Access Compliance Report Public Rights-of-Way (Curb Ramps)

Intersection ID: 48497 Main Street: CASTLECOVE RD **Cross Street: SOLAR WY** Location: NW Initial Pass/Fail: Fail **Overall Compliance: No Severity Score:** ADA ID: 2F932308C314 Ramp Type: PerpDiag 12.5

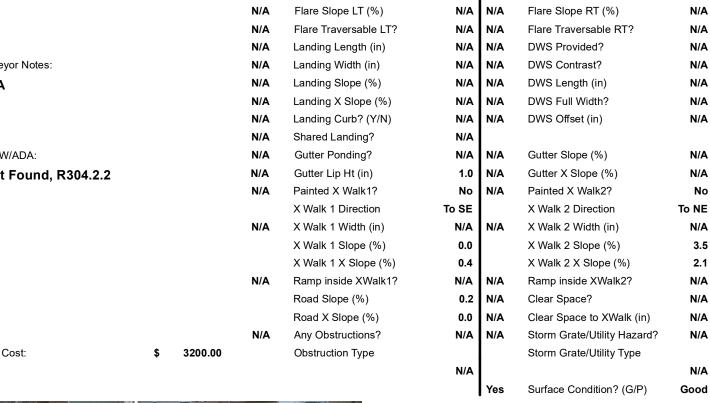
SOLAR WY StopSign **CASTLECOVE RD** None Possible Solutions: Remove & Replace Curb Ramp With Two New Directional Ramps or Equivalent. Surveyor Notes: N/A PROW/ADA:

Not Found, R304.2.2
